Western Digital Corporation
20511 Lake Forest Drive
Lake Forest, CA 92630

To: T10 CAP Working Group
Contact: Curtis E. Stevens
Phone: 949-672-7933
Email: Curtis.Stevens@wdc.com
Date: November 5, 2008

Subject: UAS Clause 6 (Usage)

This proposal defines the Usage clause for UAS. The Usage clause describes the communication sequences between the UAS initiator port and the UAS target port.

Figure 1 — Sequence figure notation

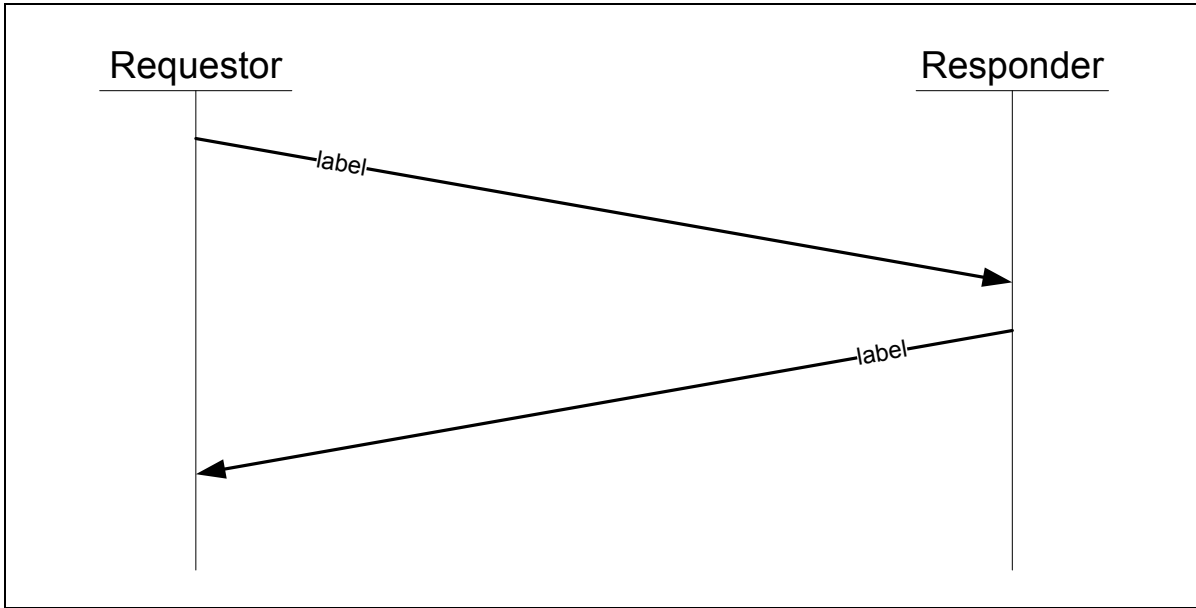
3.6 Sequence figure notation

A Sequence Figure describes sequences of communication between a requestor and a responder. Figure 1 is an example Sequence Figure. Arrows that start at the requestor and end at the responder represent communication from the requestor to the responder. Arrows that start at the responder and end at the requestor represent communication from the responder to the requestor.

Each arrow has a label. The label describes the communication between the requestor and the responder.

The sequence figures start at the top and progress in time toward the bottom.

Figure 2 — UAS sequence figure notation

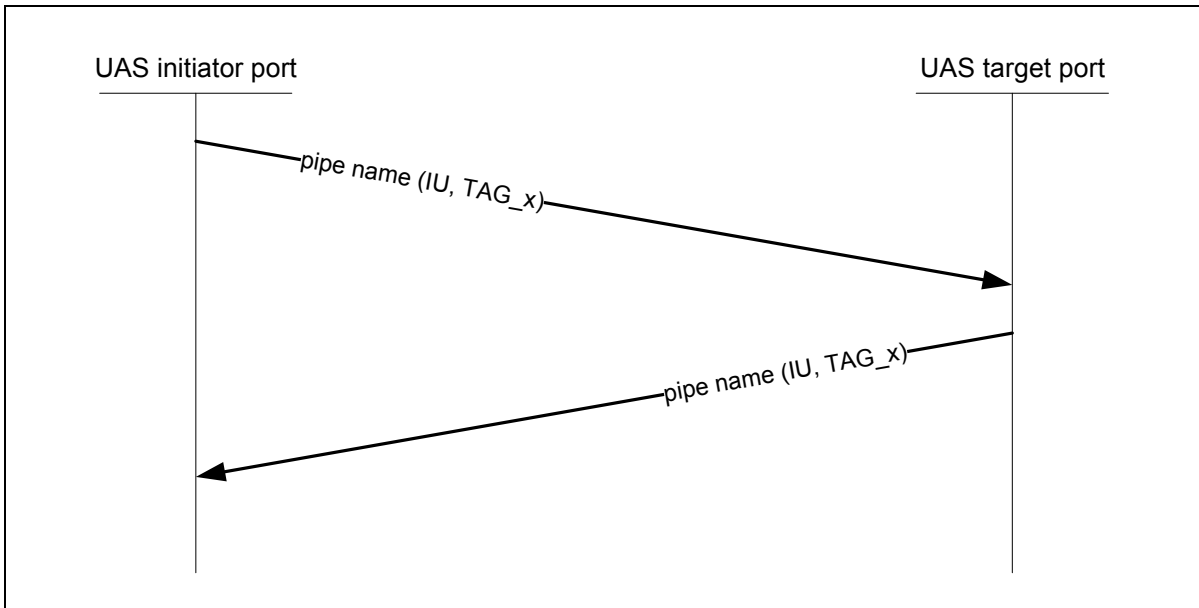
The Sequence Figures in this subclause describe communication between an UAS initiator port and a UAS target port. Figure 2 is an example UAS Sequence Figure. In figure 2, arrows that start at the UAS initiator port and end at the UAS target port represent communication from the UAS initiator port to the UAS target port and arrows that start at the UAS target port and end at the UAS initiator port represent communication from the UAS target port to the UAS initiator port. Each arrow has up to 3 elements:

- a) pipe name is the name of a USB pipe as described in clause 4xxxx;
- b) IU is an optional parameter which indicates the Information Unit (See 6.2xxx) that is transferred on the pipe; and
- c) TAG_x is an optional parameter that provides information regarding a field in an IU.

Only the command pipe (see xxxx) and the status pipe (see xxxx) use the IU and TAG_x parameters. The data-in (see xxxx) and data-out (see xxxx) transfer data associated with commands.

Figure 3 — Non-data Transfer

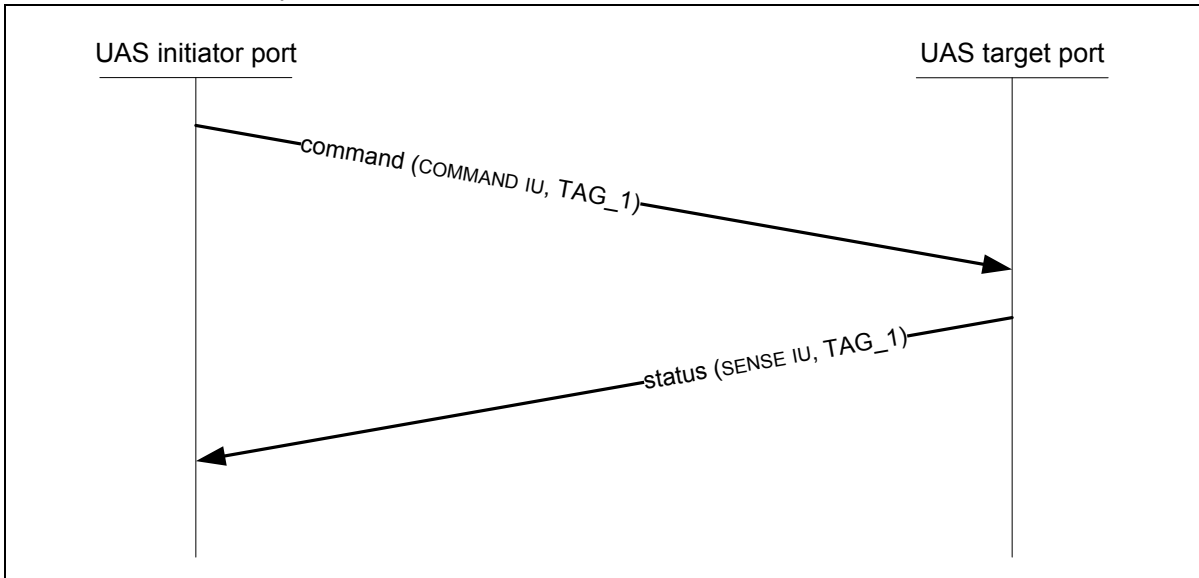
Figure 3 describes the sequence of communication between the UAS initiator port and UAS target port for a command that does not require data transfer.

Figure 4 — Write Data Transfer

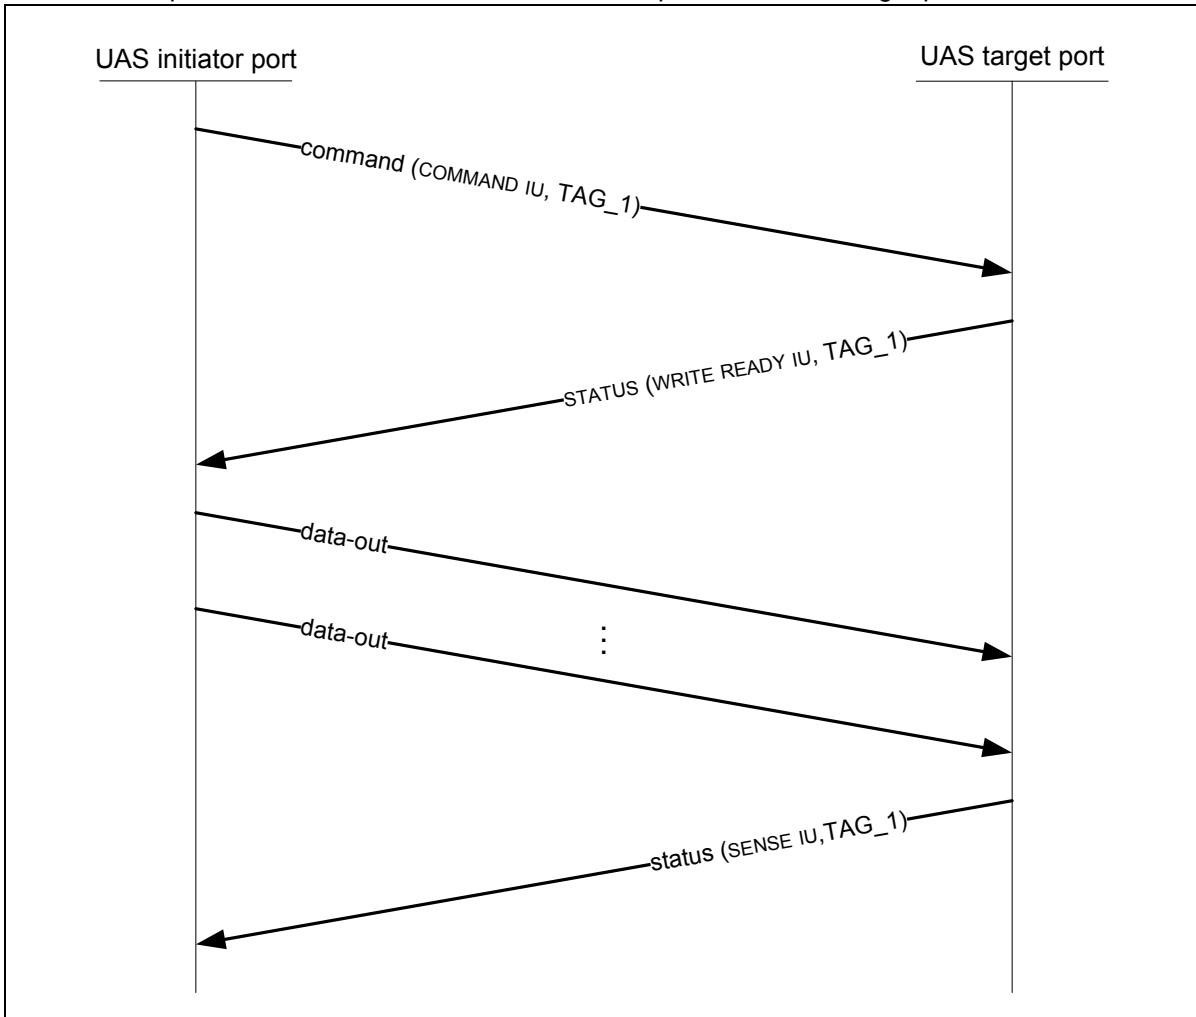
Figure 4 describes the sequence of communication between the UAS initiator port and UAS target port for a command that requires data transfer from the UAS initiator port to the UAS target port.

Figure 5 — Read Data Transfer

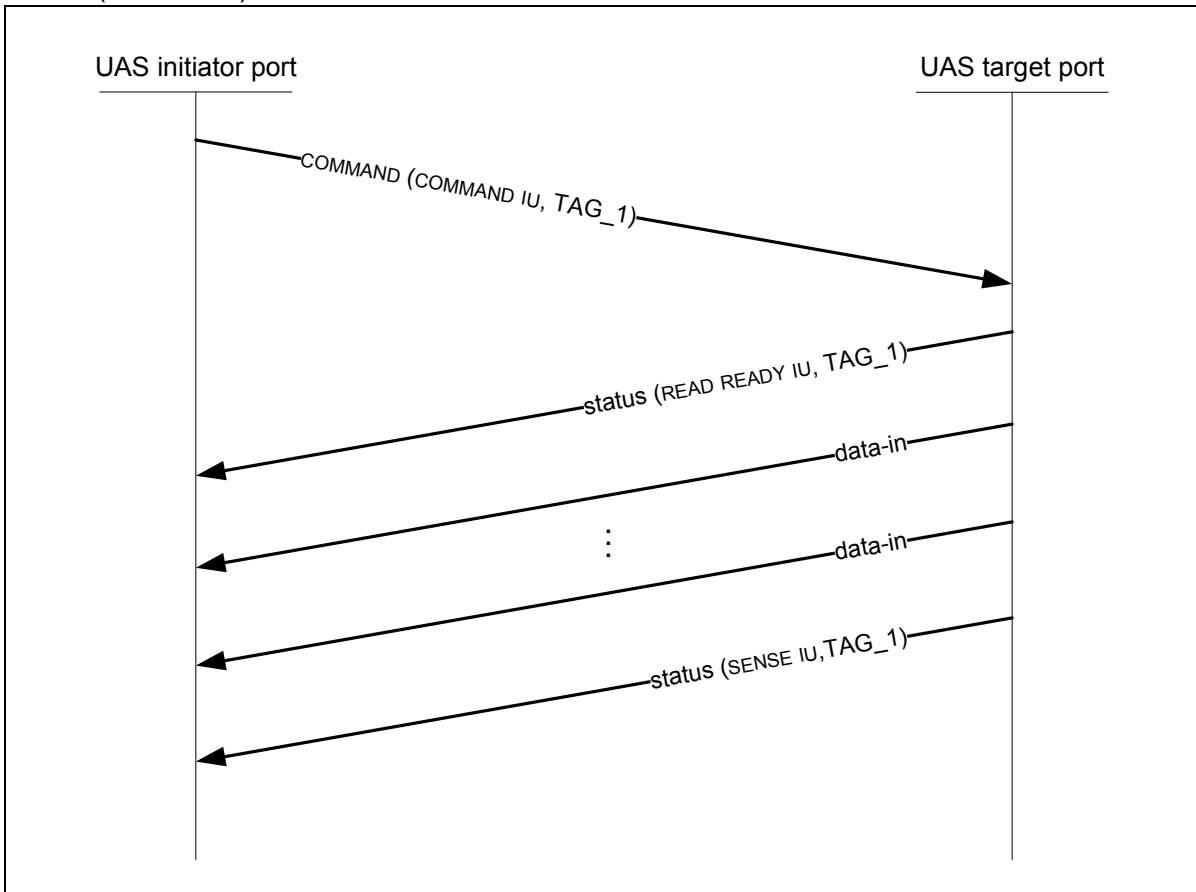
Figure 5 describes the sequence of communication between the UAS initiator port and UAS target port for a command that requires data transfer from the UAS target port to the UAS initiator port. The UAS target port shall not transmit the SENSE IU before the USB initiator port has acknowledged that all of the data has been transferred (See USB-2).

Figure 6 — Task Management

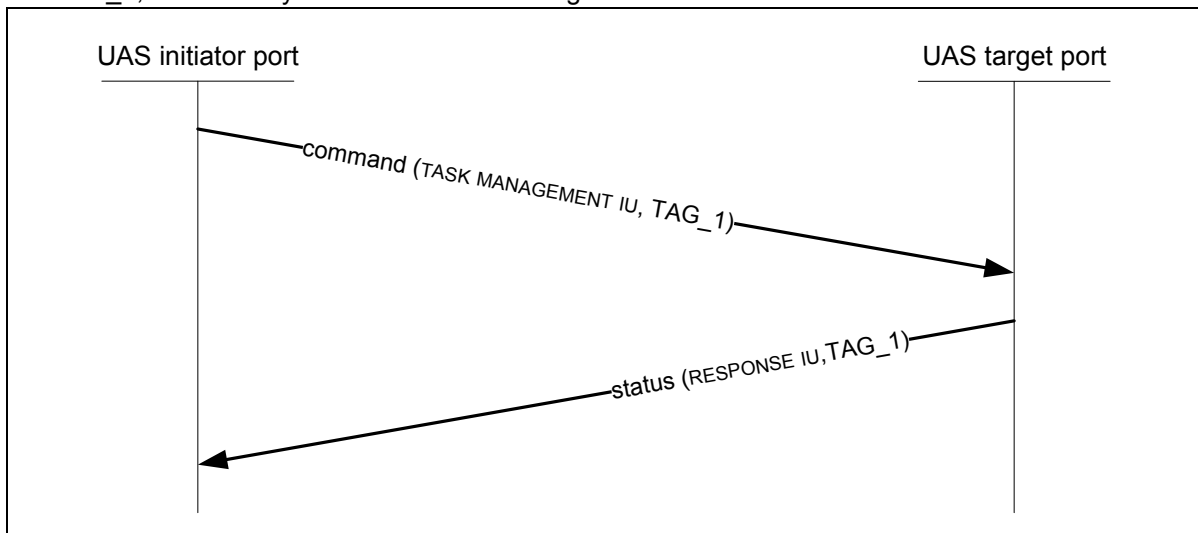
Figure 6 describes the sequence of communication between the UAS initiator port and UAS target port for a task management command that is received by the UAS target port and then subsequently aborted by the UAS initiator port. In this example, there is no SENSE IU returned by the device because the TASK MANAGEMENT IU, with TAG_1, successfully aborted the outstanding command.

Figure 7 — Bi-directional Data Transfer

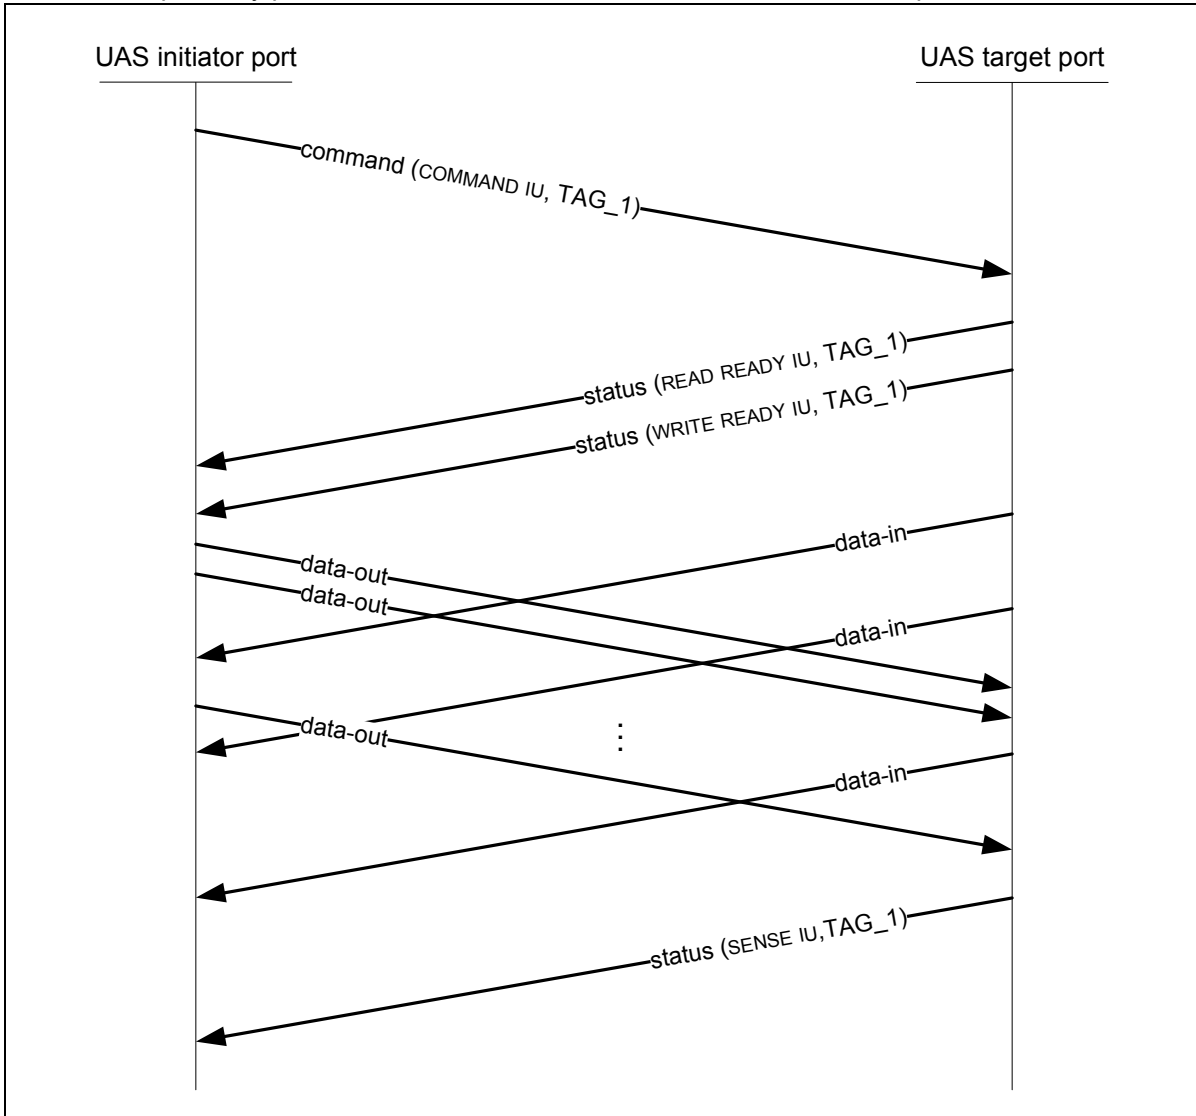
Figure 7 describes the sequence of communication between the UAS initiator port and UAS target port for a command that requires data transfer both directions between the UAS target port and the UAS initiator port. Once the READ READY IU and WRITE READY IU are received by the UAS initiator port, both data-in and data-out transfer occur asynchronously. The UAS target port may send the READ READY IU and wait for the data-in transfer to complete and then send the WRITE READY IU and then wait for data-out transfer to complete; or vice versa. Although figure 7 shows that the SENSE IU is transferred when the last data-in transfer has completed, the UAS initiator port may process the SENSE IU before the data-in transfer is complete.

NOTE 1 - The order of the data-in and data-out phases of a bidirectional command may be influenced by both the definition of the bidirectional command and the capabilities of the USB target.

Figure 8 — Multiple Command Example

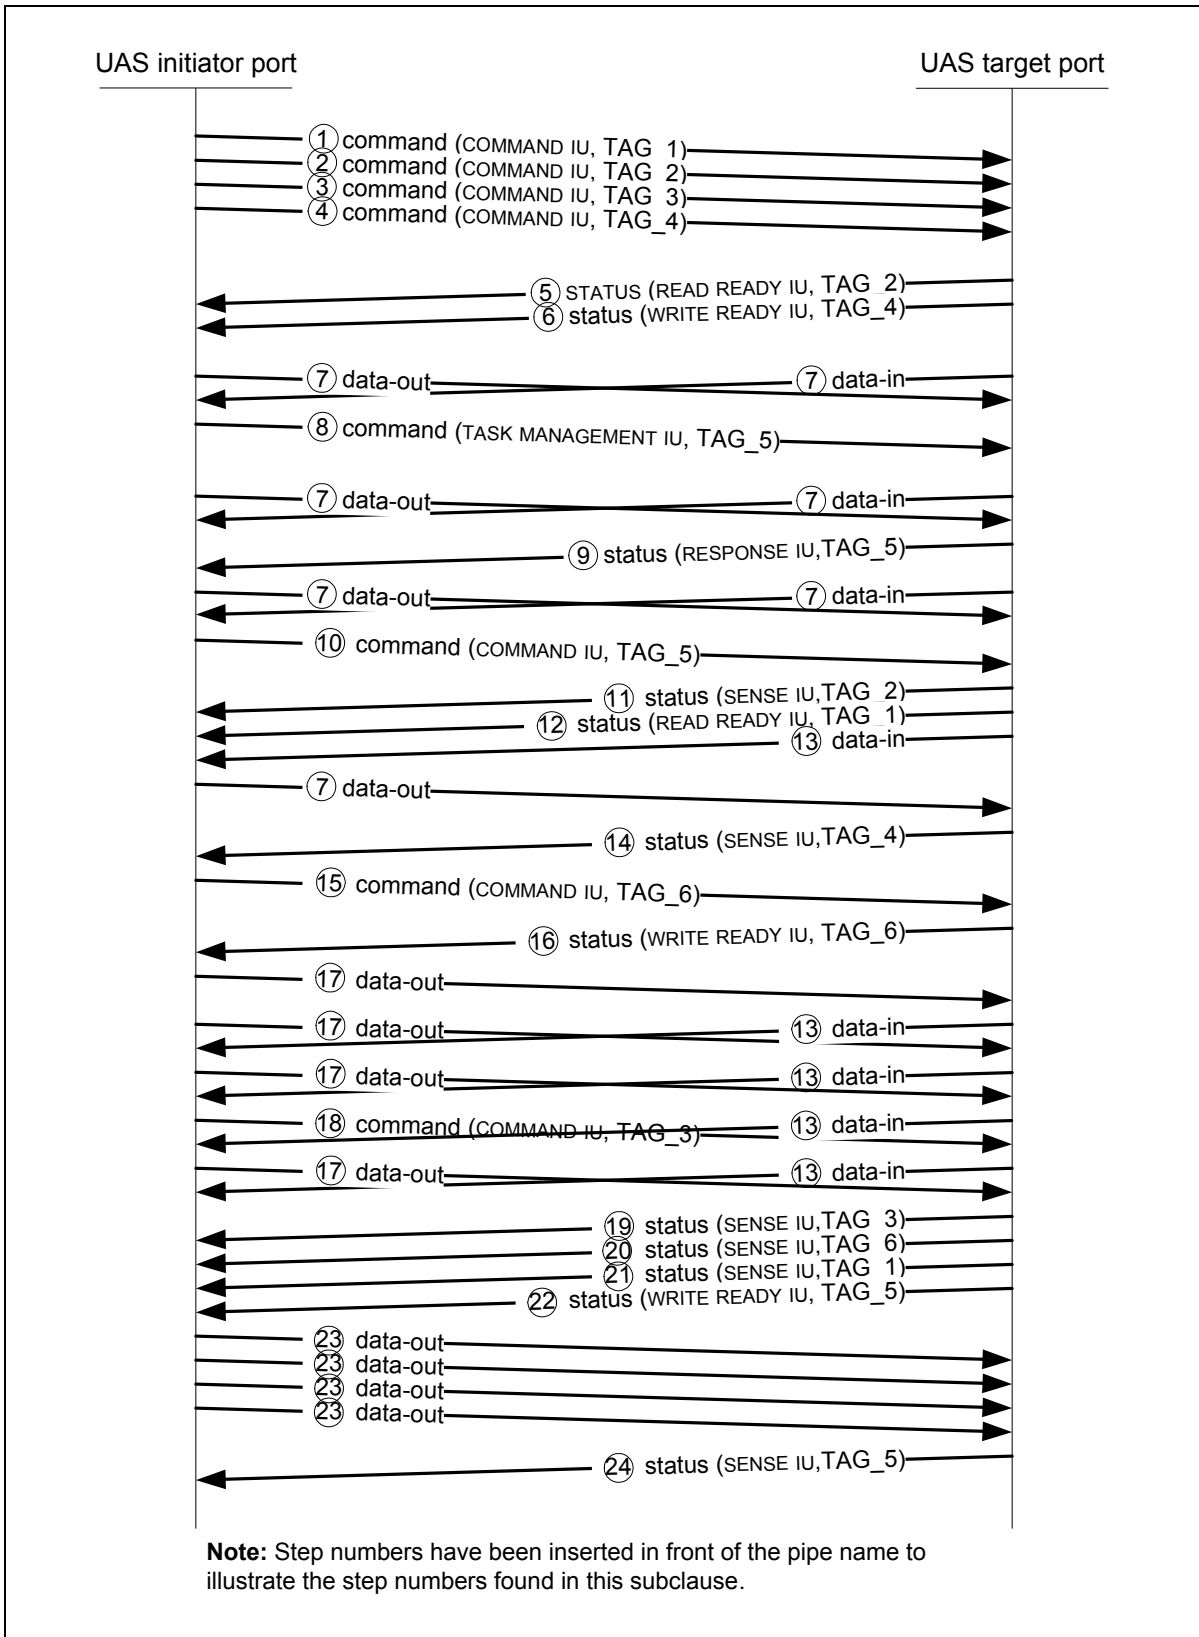
Figure 8 describes the sequence of communication between the UAS initiator port and UAS target port for several commands using the simple queuing model (see SAM-4) as follows:

- 1) the UAS initiator port transfers a read command with an INITIATOR PORT TRANSFER TAG of TAG_1;
- 2) the UAS initiator port transfers a read command with an INITIATOR PORT TRANSFER TAG of TAG_2;

- 3) the UAS initiator port transfers a write command with an INITIATOR PORT TRANSFER TAG of TAG_3
- 4) the UAS initiator port transfers a write command with an INITIATOR PORT TRANSFER TAG of TAG_4;

- 5) the UAS target port requests to transfer the read data for INITIATOR PORT TRANSFER TAG of TAG_2;
- 6) the UAS target port requests to transfer the write data for INITIATOR PORT TRANSFER TAG of TAG_4;

- 7) data transfer begins for both TAG_2 and TAG_4
- 8) the UAS initiator port transfers a task management request (using the INITIATOR PORT TRANSFER TAG of TAG_5) to abort the command with INITIATOR PORT TRANSFER TAG of TAG_3;

- 9) the UAS target port reports that the command with INITIATOR PORT TRANSFER TAG TAG_3 was successfully aborted;
- 10) the UAS initiator port transfers a write command with an INITIATOR PORT TRANSFER TAG of TAG_5;

- 11) the UAS target port reports command completion for INITIATOR PORT TRANSFER TAG TAG_2;
- 12) the UAS target port requests to transfer the read data for INITIATOR PORT TRANSFER TAG of TAG_1;

- 13) the UAS target port begins transferring data for INITIATOR PORT TRANSFER TAG TAG_1;
- 14) the UAS target port reports command completion for INITIATOR PORT TRANSFER TAG TAG_4;

- 15) the UAS initiator port transfers a write command with an INITIATOR PORT TRANSFER TAG of TAG_6;
- 16) the UAS target port requests the write data for INITIATOR PORT TRANSFER TAG of TAG_6;

- 17) the UAS initiator port begins transferring data for INITIATOR PORT TRANSFER TAG TAG_6;
- 18) the UAS initiator port transfers a command which does not require data transfer with an INITIATOR PORT TRANSFER TAG of TAG_3;

- 19) the UAS target port reports command completion for INITIATOR PORT TRANSFER TAG TAG_3;
- 20) the UAS target port reports command completion for INITIATOR PORT TRANSFER TAG TAG_6;

- 21) the UAS target port reports command completion for INITIATOR PORT TRANSFER TAG TAG_1;
- 22) the UAS target port requests the write data for INITIATOR PORT TRANSFER TAG of TAG_5;

- 23) the UAS initiator port begins transferring data for INITIATOR PORT TRANSFER TAG TAG_5;
- 24) the UAS target port reports command completion for INITIATOR PORT TRANSFER TAG TAG_5; and

- 25) the UAS target port is idle.
